Docket Item #5
BAR CASE #2004-0274

BAR Meeting
January 26, 2005

ISSUE: Garage and alterations
APPLICANT: Karen and Bill Conkey
LOCATION: 325 North Patrick Street
ZONE: RB/Residential

Figure 1 - Proposed chimney

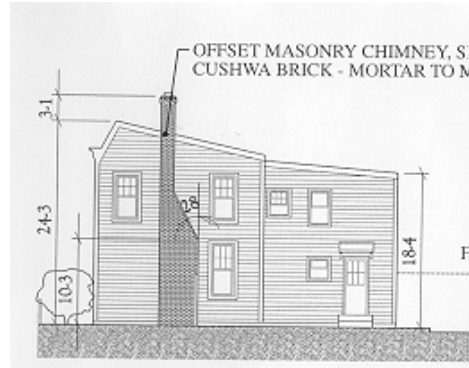
Staff is unable to recommend approval of the chimney addition as proposed. The *Design Guidelines* state that new chimneys must be appropriate to the period of the structure (Chimneys - Page 2). The Guidelines also note that the vast majority of structures in the district have

interior chimneys and flues and that “[e]xterior chimneys, that is, brick or masonry chimneys on the outside of a building wall, are found primarily on buildings dating from the late 18th and early 19th–centuries” (Chimneys - Page 1). Not only is the proposed chimney exterior, but it has the appearance of a fireplace chimney. A house of this period would most likely have been heated with stoves which tended to have narrow straight chimneys. Therefore, Staff recommends that the brick chimney be internal.

1. That the chimney be an interior brick chimney;
2. That the applicant record a zoning restriction form with the deed indicating the proposed office on the second floor of the garage will be used only as an office and not as a separate dwelling;
3. That the garage be clad in vertical board-and-batten fiber cement siding;
4. That the fiber cement be smooth finish and painted;
5. That the fence be painted or stained; and,
6. That the statements below must appear in the General Notes of the site plan so that on-site contractors are aware of the requirements:

Figure 2 - Proposed new garage/office

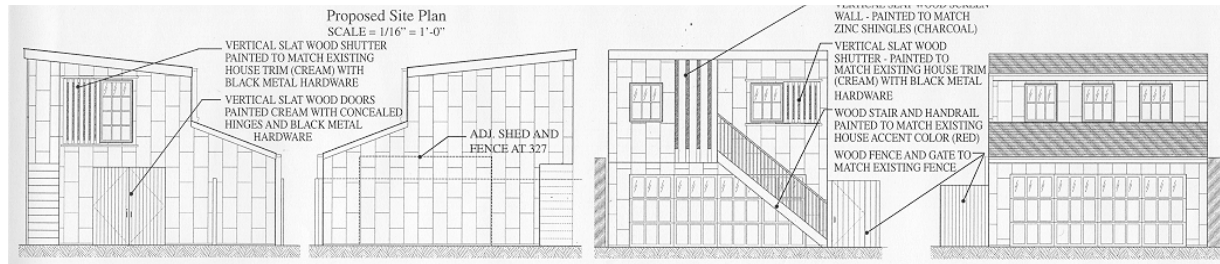
Staff recommends approval of the garage with some reservations. The *Design Guidelines* state that “accessory structures should complement, not compete with, the architecture of the main building” (Accessory Structures - Page 2). In the opinion of Staff, the unusual design of the garage, with its cantilevered form, modern detailing and use of a zinc wall system, can not be said to complement the late 19th century, clapboard clad house and could even be said to compete with the house if the two structures were visible side-by-side. However, Staff believes that the proposed design is generally acceptable in that the contrast between the new garage and historic house is most evident from within the property and will not be readily discernable from the public right-of-way. The garage should be barely, if at all visible from Patrick Street. While it will be visible from the public alley behind the property and from oblique views down the alley from Princess Street, that portion of the garage that will be visible is more conventional than the yard side.

However, Staff feels the use of the zinc wall system is inappropriate and accentuates the modern and unusual appearance of the new building to an unnecessary degree. The applicant has argued that this treatment is historically appropriate as many of the district’s older sheds and garages that remain are clad in metal. The use of corrugated or flat sheets of metal cladding to cover these simple frame structures appears to have been popular from circa 1920 through circa 1940. It often was used as a replacement cladding after the original wood siding had failed. The material is not characteristic of the late 19th century period of the house at 325 North Patrick Street and its neighbors. The appearance is industrial rather than residential in character. As an alternative, Staff recommends using painted, fiber cement planks with a smooth finish installed as vertical board-and-batten siding. Wood board-and-batten siding was commonly used for outbuildings in the latter part of the 19th century. Fiber cement is non-combustible and when painted has much the same appearance as painted wood. The Board has adopted the policy of allowing its use on non-historic structures providing that the siding is smooth (not wood grained) and that the nails do not show in the installation. According to the Hardi plank web site, fiber cement planks may be installed in a board-and-batten pattern. Staff believes this siding would help tie the new structure to the historic house in its visual character while still maintaining the clean vertical lines that the applicant desires.

- The exterior covering shall be comprised of non-combustible material subject to the approval of the Director of Code Enforcement.
- C-1 All exterior walls within 5 feet from an interior property line shall have a fire resistance rating of 1 hour, from both sides, with no openings permitted within the wall. As alternative, a 2 hour fire wall may be provided. This condition is also applicable to skylights within setback distance.
